STATE OF ILLINOIS  
DEPARTMENT OF TRANSPORTATION

F&P RTL	SECTION	COUNTY	TOTAL SHEETS	SHEET NO.
711	ISBY-DBR	VERMILION	93	64 A
FED. ROAD DIST. NO.	ILLINOIS	FED. AID PROJECT		
CONTRACT NO. 90843

**CONCRETE PARAPET  
SLIPFORMING OPTION**

Added 2-25-05

**SECTION**  
(Showing dimensions)

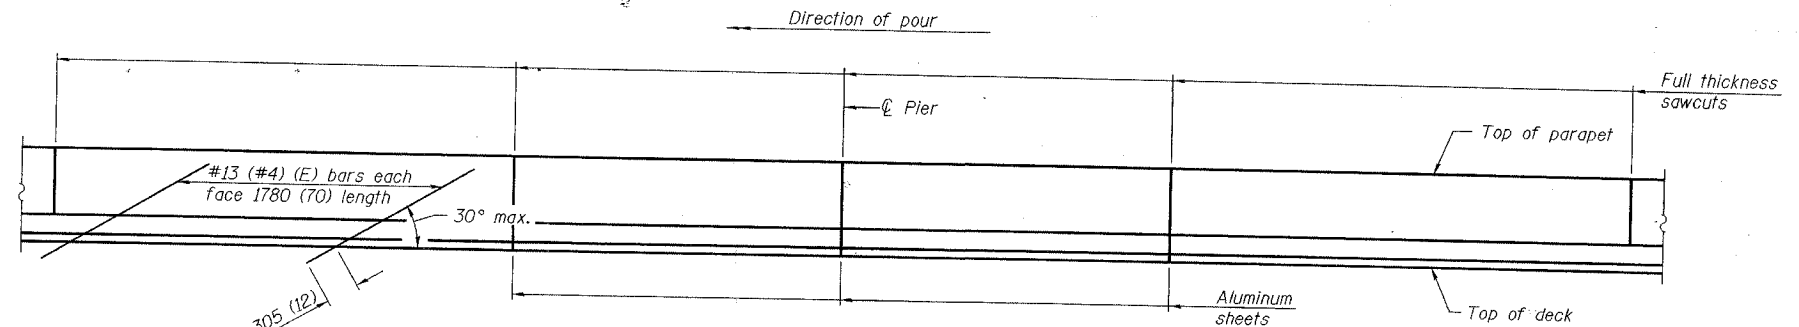
All dimensions shall remain the same as shown on contract plans, except dimensions A and B which are to be revised as shown to provide additional clearance. Additional concrete needed to revise dimension A and B= 0.0422 m<sup>3</sup>/m (0.165 cu. yds./ft.) of parapet. Place aluminum sheet in curb portion at and near piers. Full thickness saw cut at all other locations. Adjust/add joint locations to maintain 3 to 6 meter (10 to 20 foot) spacing.
